This document is a response to the Third Submission Review of the E-470 & 6th Parkway Infrastructure Site Plan (Application Number: DA-2134-02 / Case Number: 2022-6033; 2022-3050-00) received on February 3, 2023, from Planning and Development Services. Responses are below in **RED**:

E470 AND 6TH PARKWAY

INFRASTRUCTURE SITE PLAN

E470 & 6TH PARKWAY
INFRASTRUCTURE SITE PLAN
PROPOSED SIGNAGE AND STRIPING PLAN

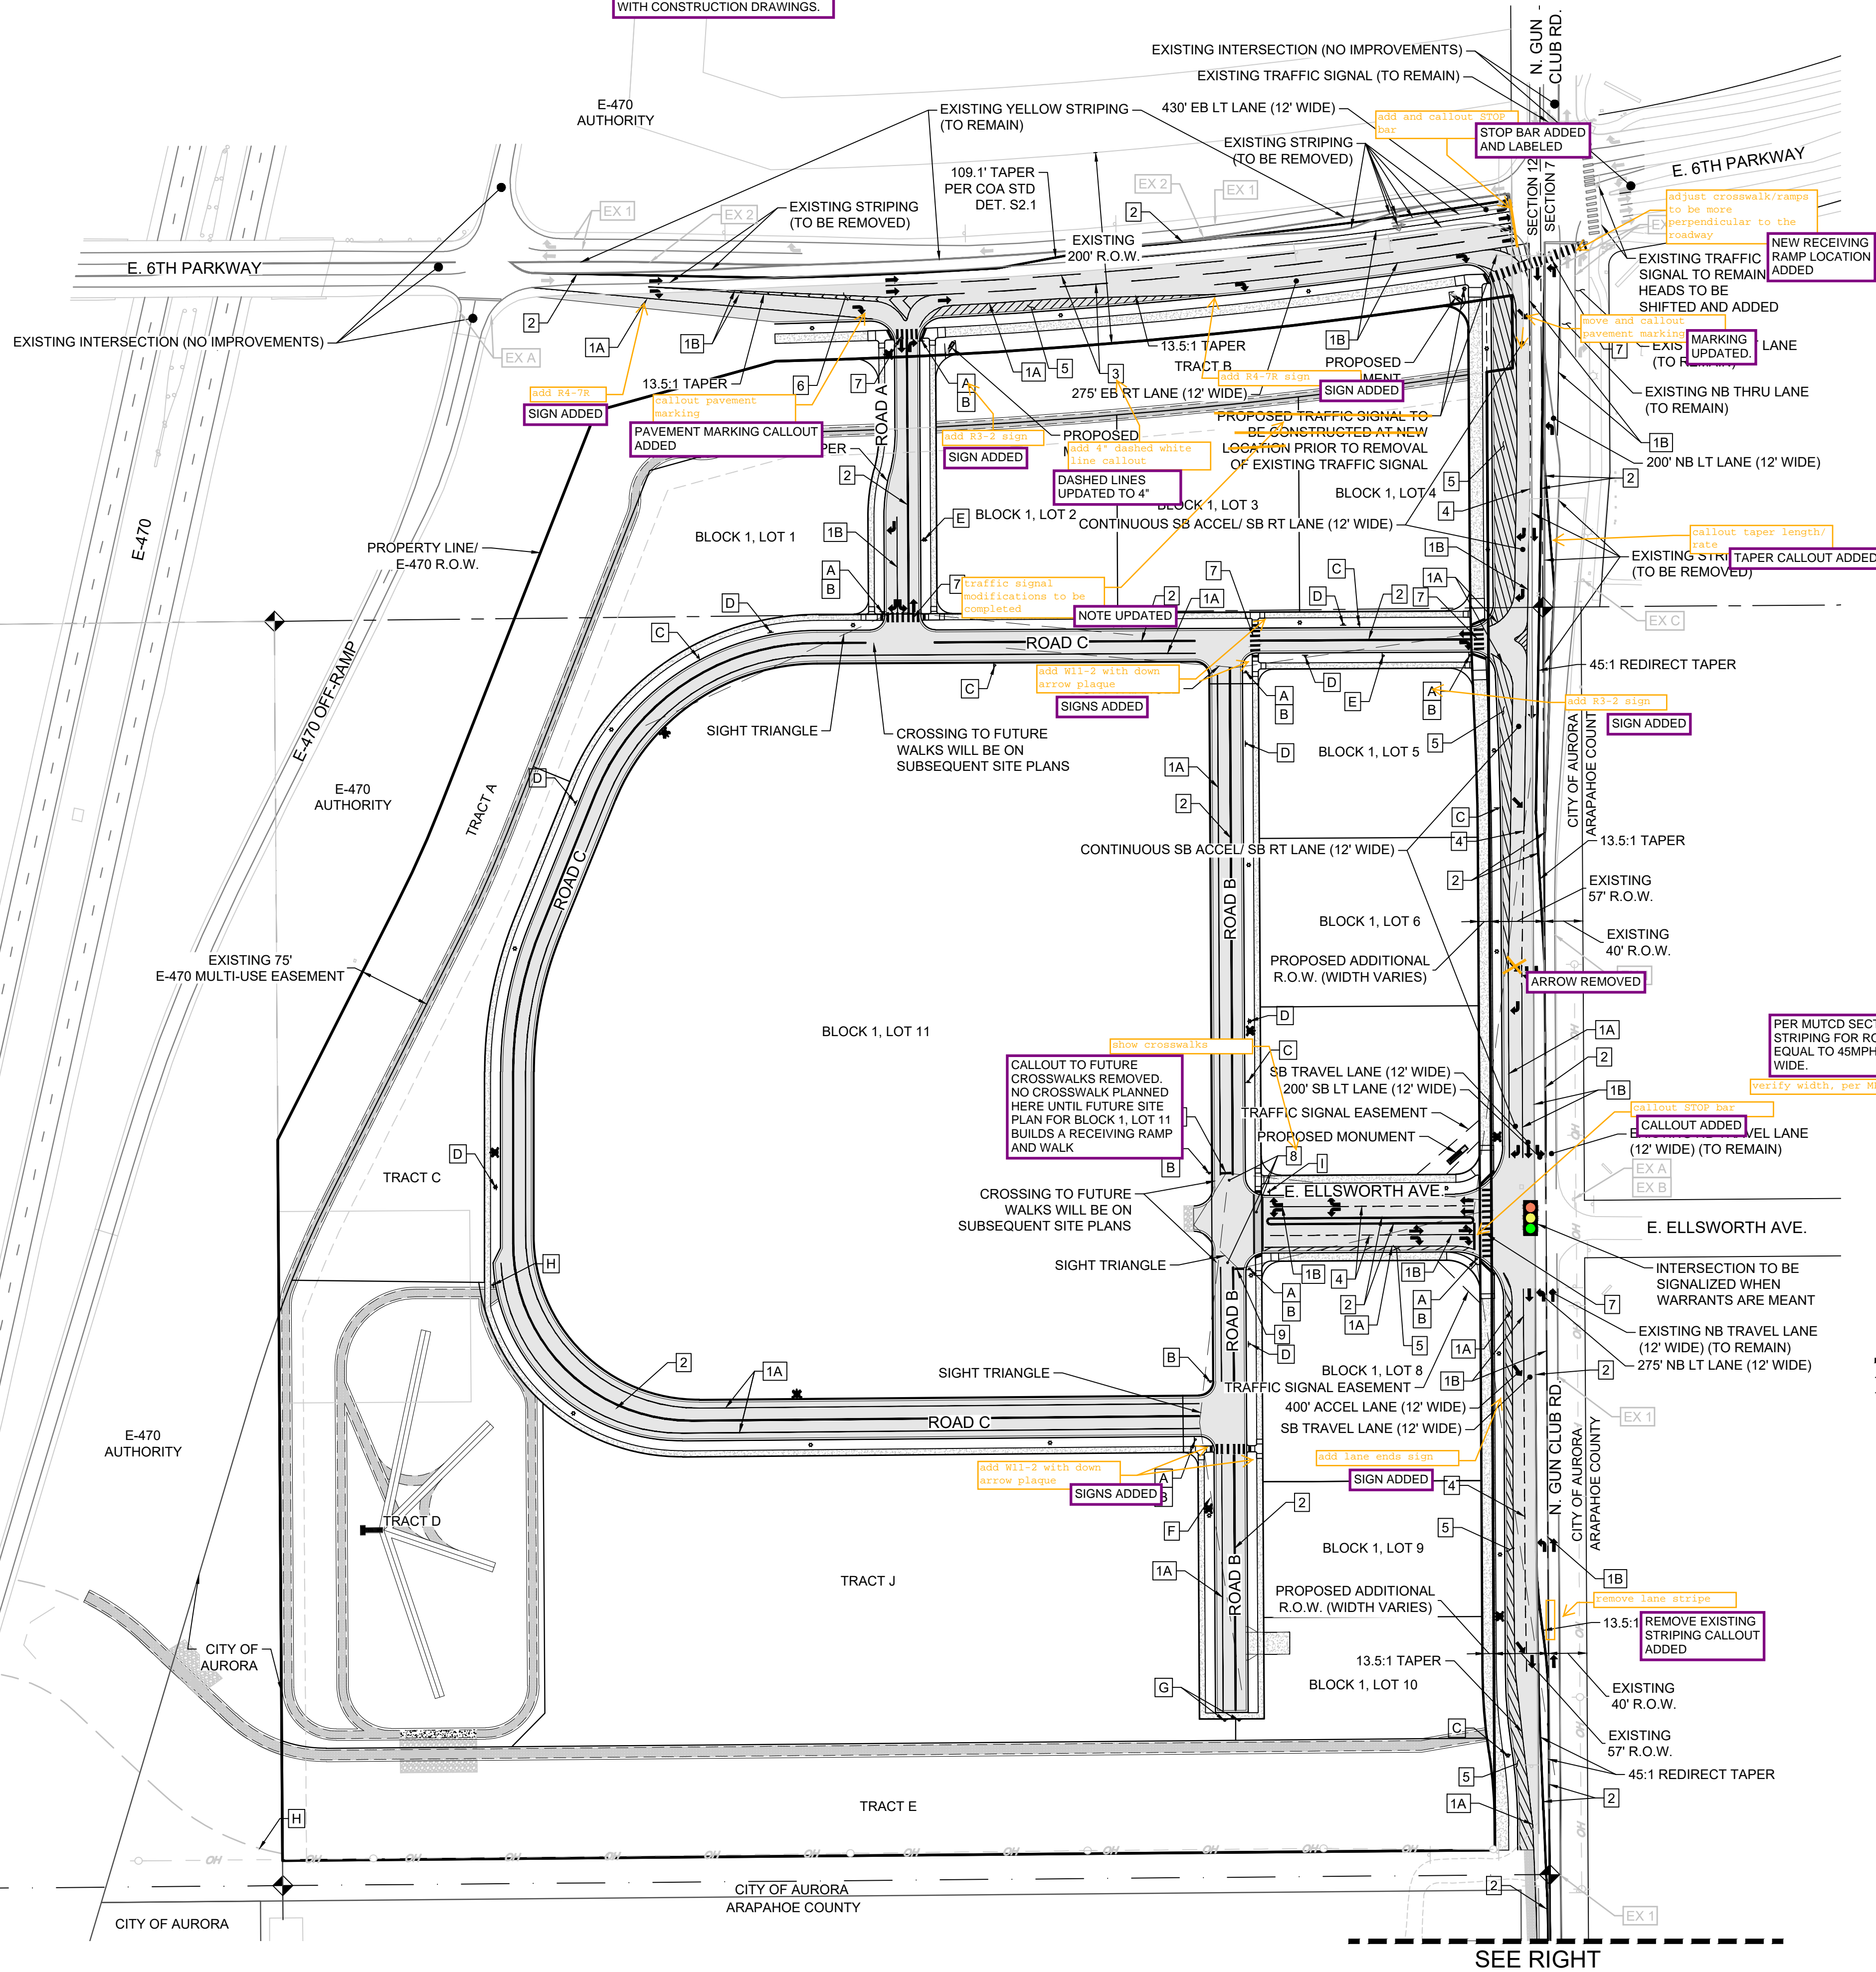
1. callout all taper lengths and rates
2. callout all lane widths

ADDITIONAL TAPER LABELS ADDED, MORE DETAILED SMALLER SCALE STRIPING PLANS TO BE PROVIDED WITH CONSTRUCTION DRAWINGS.

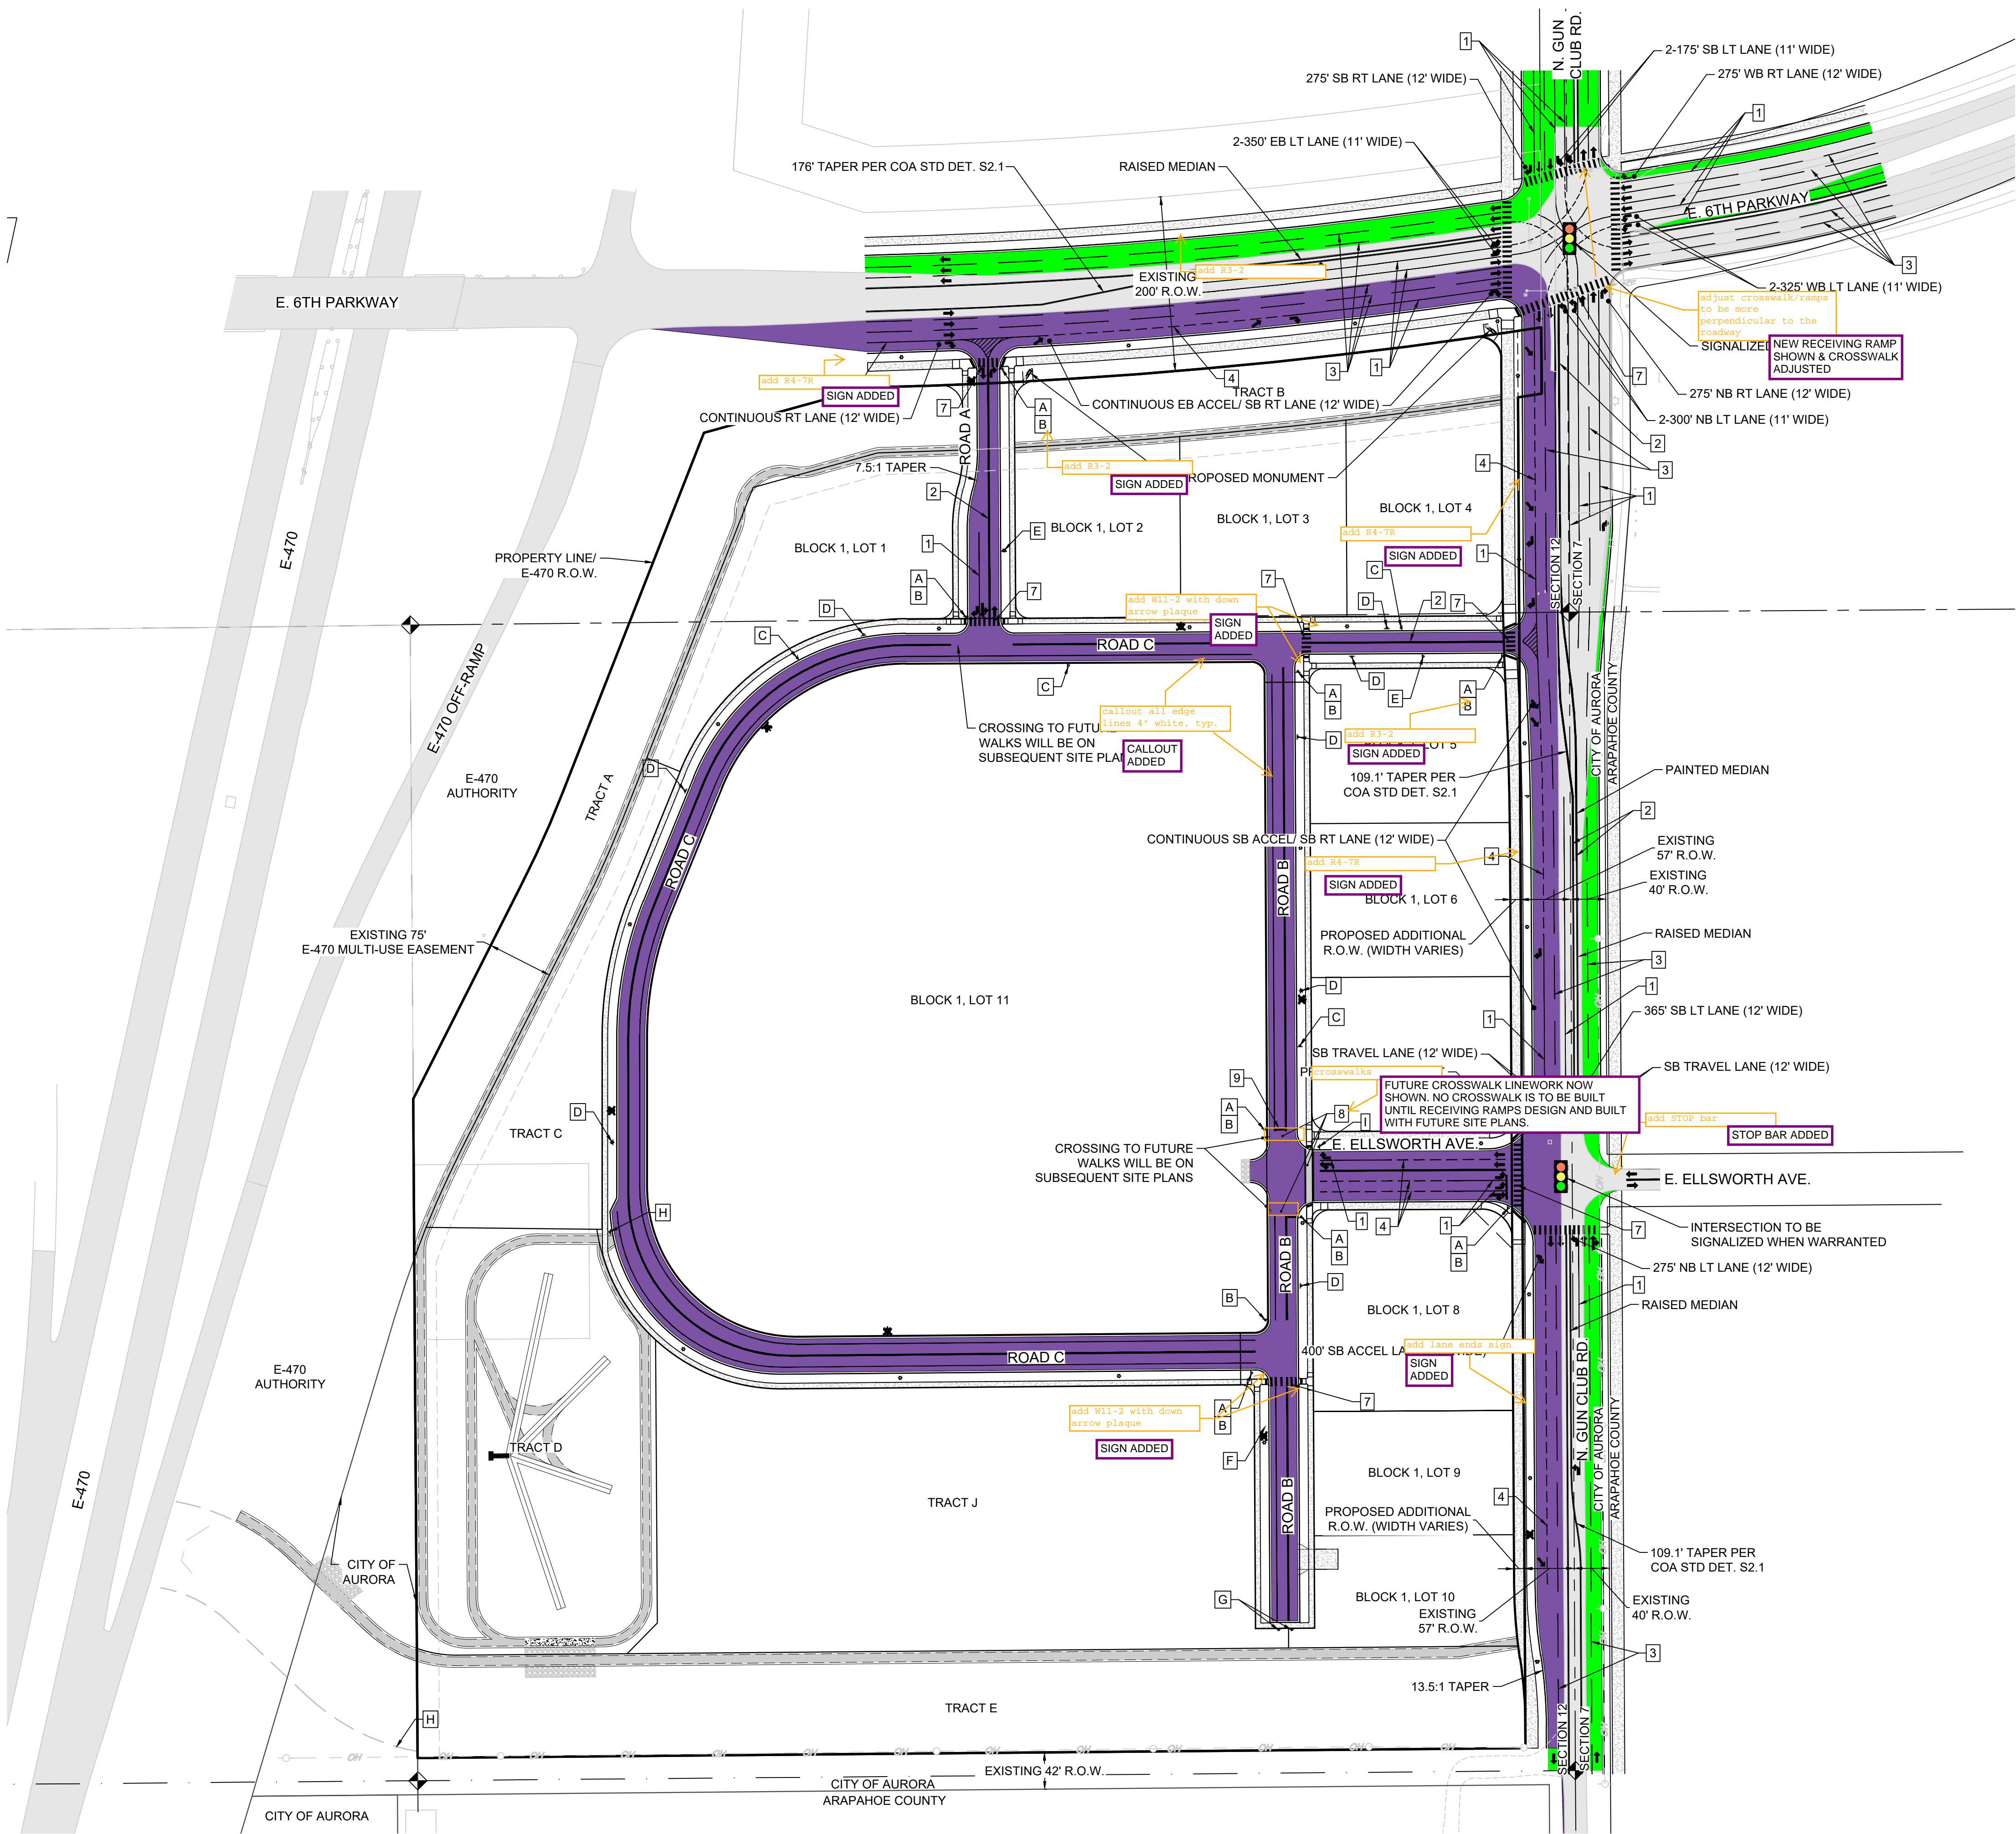
1. callout all taper lengths and rates
2. callout all lane widths
TAPER AND LANE WIDTH
CALLOUTS ADDED
